Re: Correction Letter
Sonny's Direct
Lee's Summit, MO

Permit No: PRCOM20253506
Project Title: SONNYS
Project Address: 2201 NE TOWN CENTRE BLVD, LEES SUMMIT, MO 64064
Parcel Number: 52500022800000000
Location / Legal Description: TOWN CENTRE LOGISTICS LOT 1 & TRACT A---LOT 1

This is a response to your Plan Review Conditions letter dated 8/29/25

OCCUPANCY CLASSIFICATION:	B_BUSINESS	2,423 S.F.
	H-3 HIGH HAZARD	17,165 S.F.
	S-1 MODERATE HAZARD STORAGE	4,914 S.F.
TENANT AREA (TOTAL):		24,502 S.F.
TYPE OF CONSTRUCTION:	VB 	
NUMBER OF STORIES:	1	
SPRINKLED:	YES (ESFR)	
FIRE ALARM:	YES

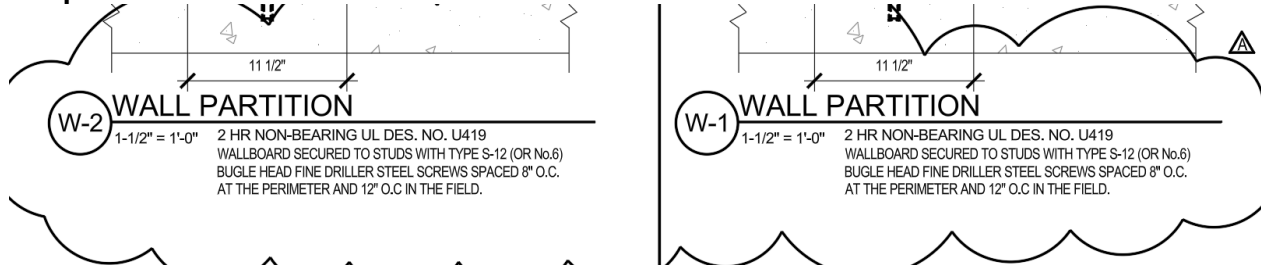
2. 2018 IBC 602.1 General. Buildings and structures erected or to be erected, altered or extended in height or area shall be classified in one of the five construction types defined in Sections 602.2 through 602.5. The building elements shall have a fire-resistance rating not less than that specified in Table 601 and exterior walls shall have a fire resistance rating not less than that specified in Table 602. Where required to have a fire-resistance rating by Table 601, building elements shall comply with the applicable provisions of Section 703.2. The protection for openings, ducts and air transfer openings in building elements shall not be required unless required by other provisions of this code. *Action required: Amend Fire Protection and Life Safety Code Analysis to show correct construction type which is 5B.*

Response: Building Construction Type has been changed to VB

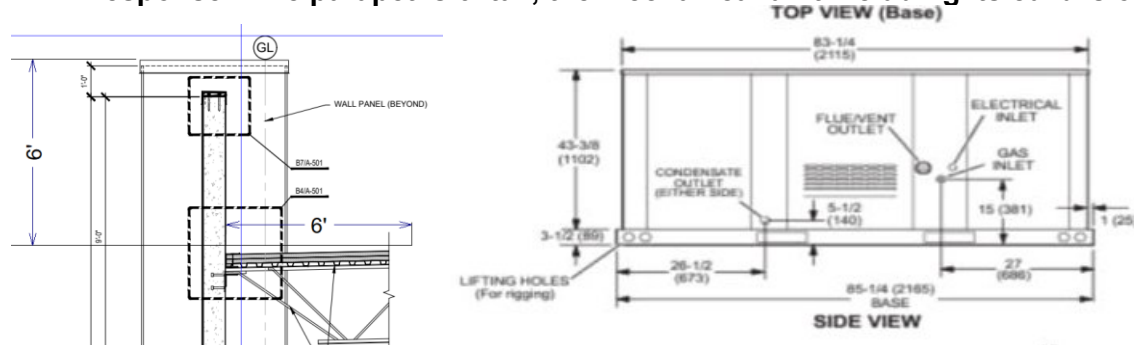
5. 2018 IMC 502.3 Battery-charging areas for powered industrial trucks and equipment. Ventilation shall be provided in an approved manner in battery-charging areas for powered industrial trucks and equipment to prevent a dangerous accumulation of flammable gases. *Action required: Provide exhaust system at battery chargers.*

Response: Ventilation for the battery chargers is shown on M2.01. Exhaust Fan #2 (EF-2) works in conjunction with Louver 2 (L-2).
